# IALA Technical Clarifications

**ITU-R M.1371-1**

**Edition 1.4**

# Technical Clarifications of Recommendation ITU-R M.1371-1 (Edition 1.4)

FIGURE 7

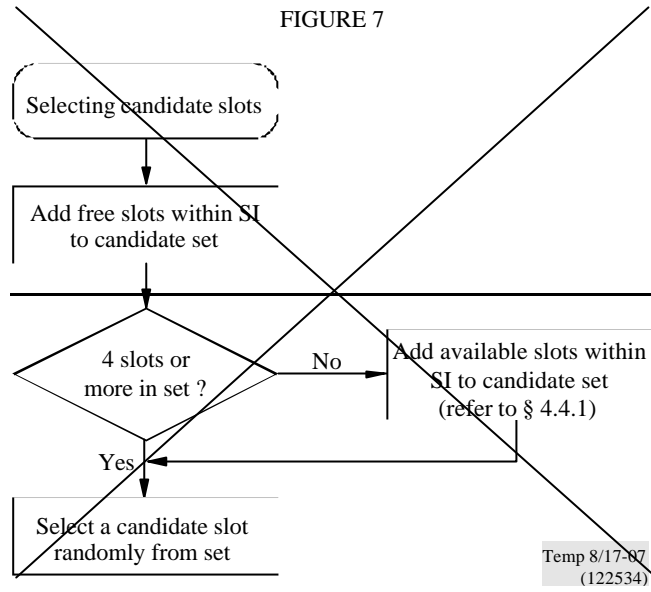
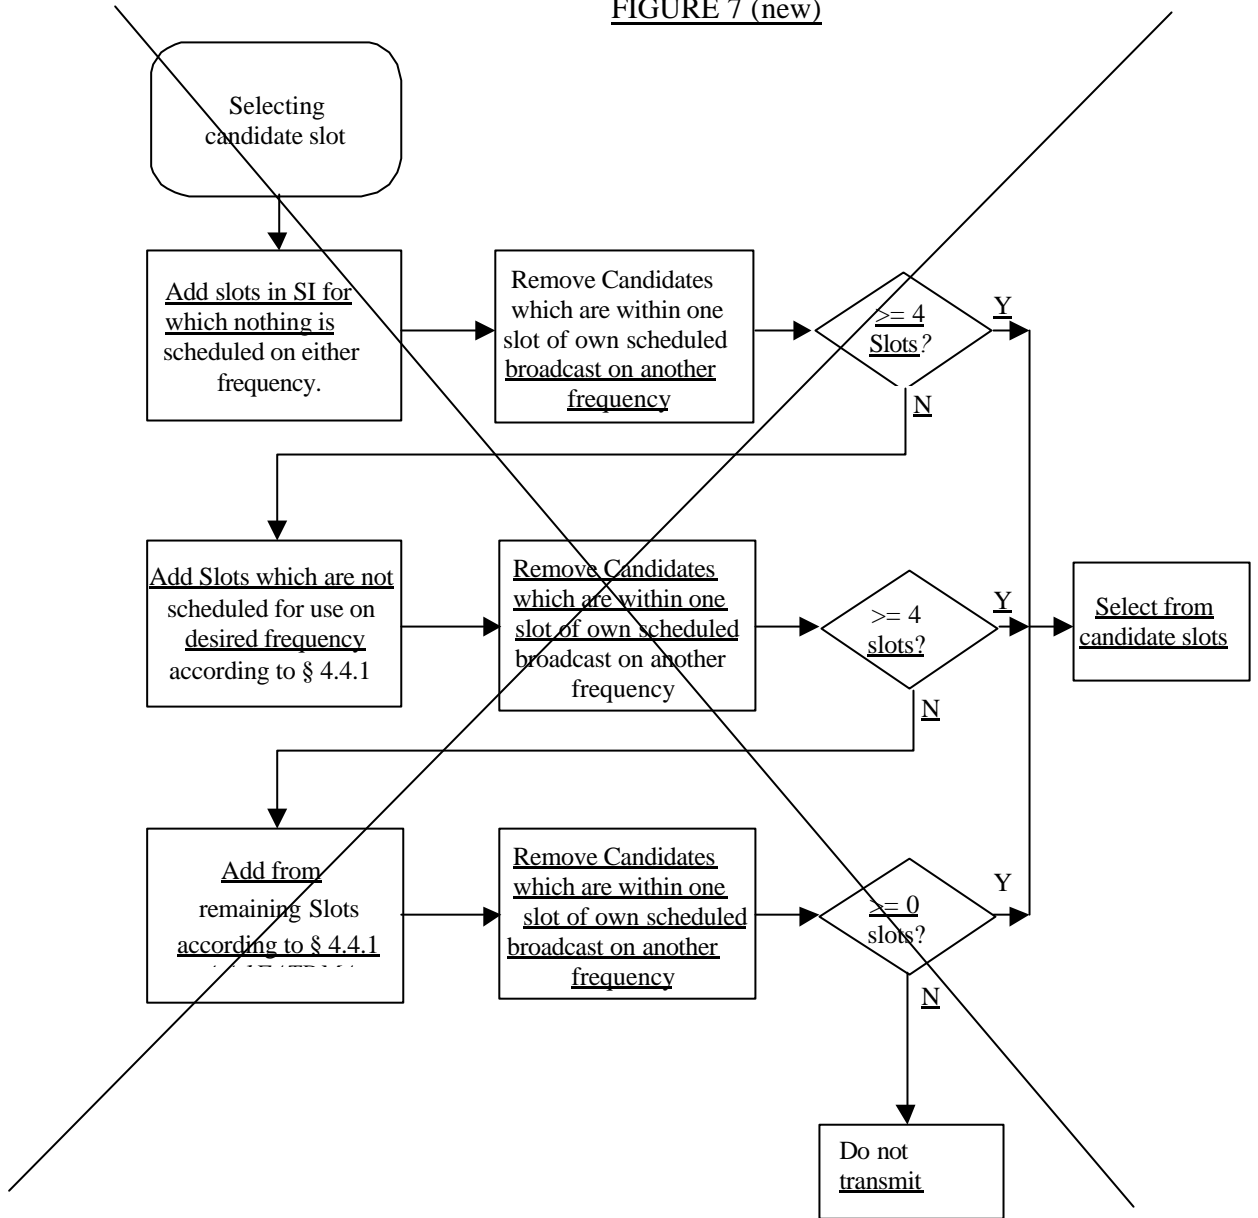
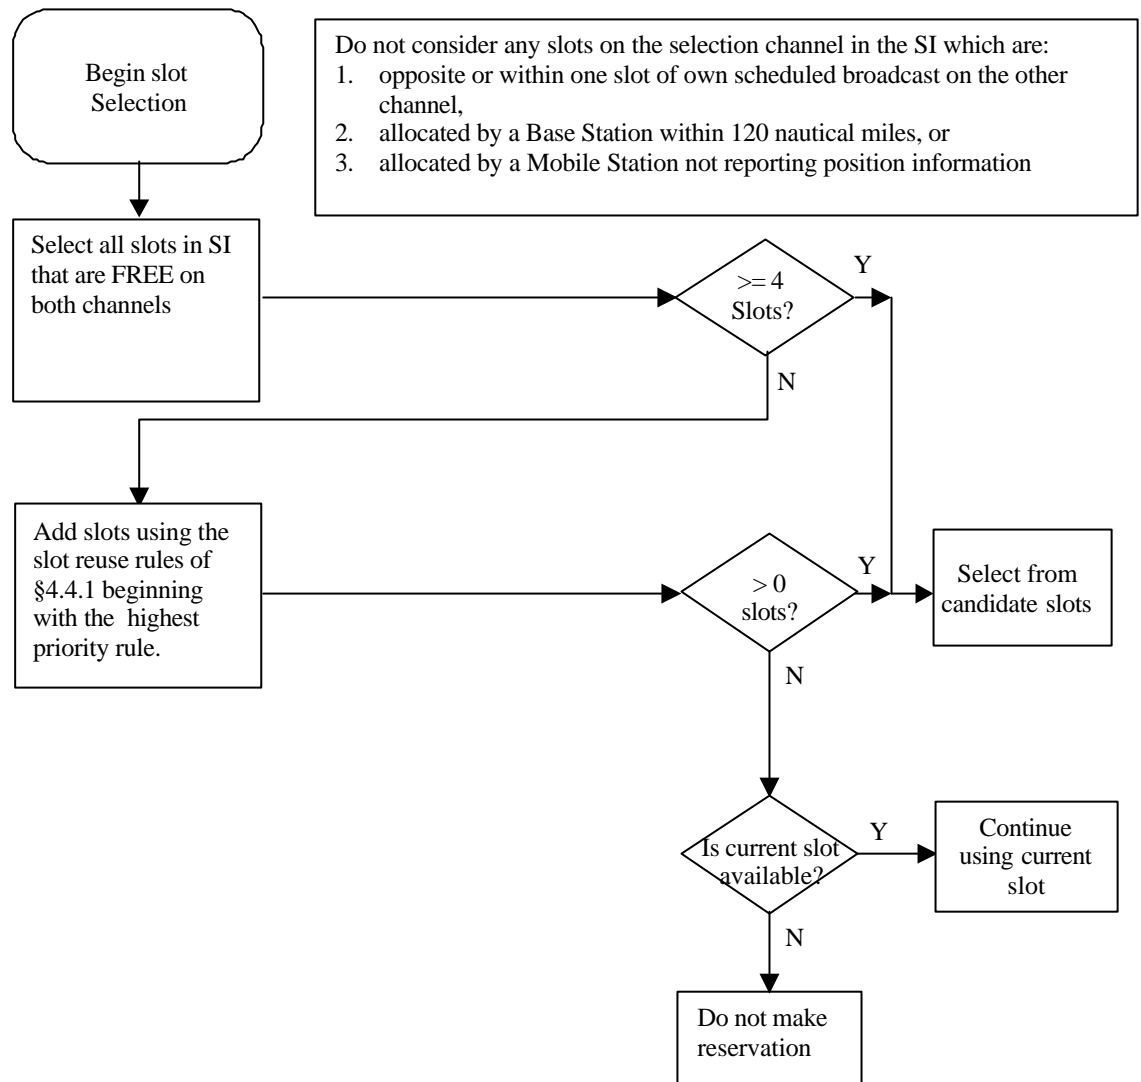
*Figure 7 illustrates the process of selecting among candidate slots for transmission on the link.*

1. Words were added to recognize that received data and signal information can also be used in the slot selection process.
2. Wording was changed to improve the precision of the material.
3. Figure 7 was revised to:
  - clarify the slots that cannot be considered for reuse,
  - simplify the diagram, and
  - improve clarity.

FIGURE 19a

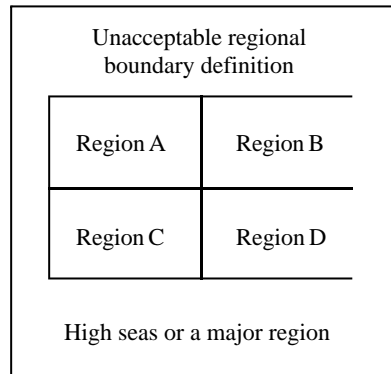
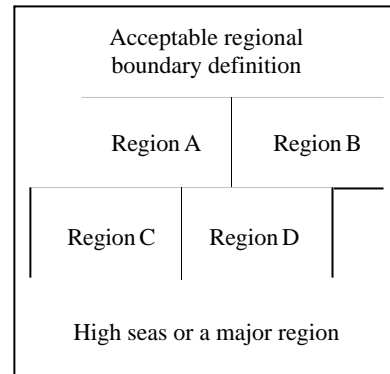
*The AIS device should automatically switch to the two-channel transitional operating mode when it is located within five nautical miles, or the transition zone size (see Table 35), of a regional boundary. In this mode the AIS device should transmit and receive on the primary AIS frequency specified for the occupied region; it should also transmit and receive on the primary AIS frequency of the nearest adjacent region. Only one transmitter is required. Additionally, for dual channel operations as specified in § 4.1.2, except when the reporting rate has been assigned by Message 16, when operating in this mode, the reporting rate should be doubled and shared between the two channels (alternate transmission mode). When the AIS is entering the transitional mode, it should continue to utilize the current channels for transmitting for a full one-minute frame while switching one of the receivers to the new channel. The TDMA access rules should be applied to vacating slots on the current channel and accessing slots on the new channel. This transitional behaviour is necessary only when the channels are changing. Regional boundaries should be established by the competent authority in such a way that this two-channel transitional operating mode can be implemented as simply and safely as possible. For example, care should be taken to avoid having more than three adjacent regions at any regional boundary intersection. In this context the high seas area should be considered to be a region where default operating settings apply. The mobile AIS station should ignore any channel management command, when there are three different regional operating settings with adjacent regional operating areas, their corners within eight miles to each other. Regions should be as large as possible. For practical purposes, in order to provide safe transitions between regions, these should be no smaller than 20 nautical miles but not larger than 200 nautical miles on any boundary side. Examples of acceptable and unacceptable regional boundary definitions are illustrated in Figures 19a and 19b.*

The corner condition for regional operating areas can be easily checked by the mobile station when receiving an channel management input. While the areas defined by the competent authority and transmitted by base stations could be assumed to be correct (the onus is on the competent authority), the mobile station may also be set by the manual input or by the shipborne system. To avoid wrong regional areas from those sources, the clarification was needed. The eight miles are derived from the maximum size of the transition zone.

Figure 21 (new)  
[Slot selection rules flow diagram]

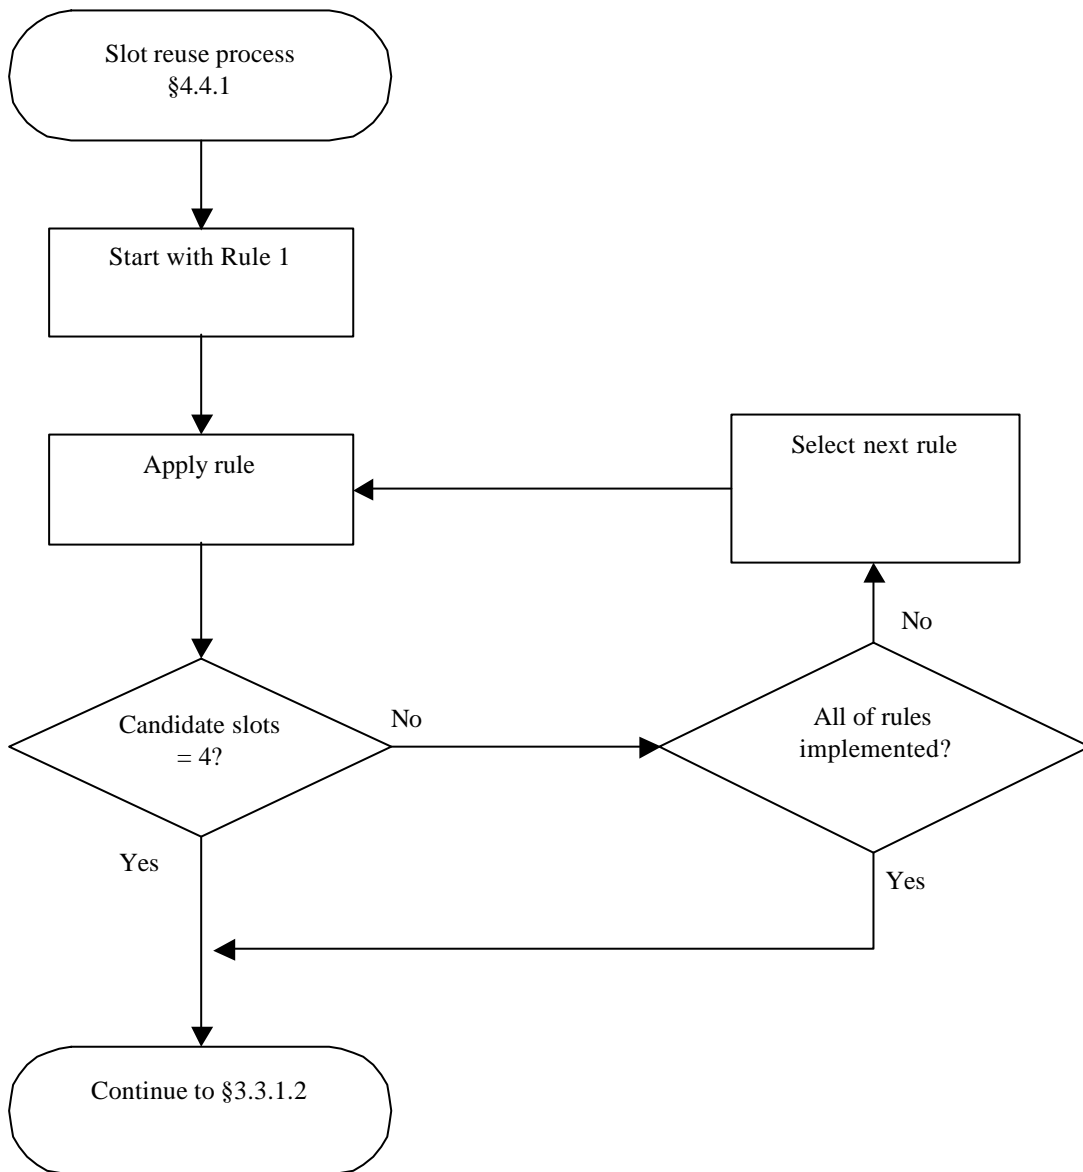
Slot reuse provides candidate slots for random selection. This process attempts to increase the candidate slot set to a maximum of four. When the candidate slot set has reached four, the candidate slot selection process is complete. If four slots have not been identified after all the rules have been applied, this process may report less than four slots. Candidate slots for reuse should be selected using the following priorities beginning with Rule 1 (Also see the slot selection rules Flow Diagram – Figure 21).

1. The slot reuse rule definitions and their selection priorities are established.
2. The order of the example's results were corrected to properly align with the use of the rules.
3. Wording adjustments were made to reference the rules.
4. A new Figure was added to define how the rules should be applied to the slot selection process.
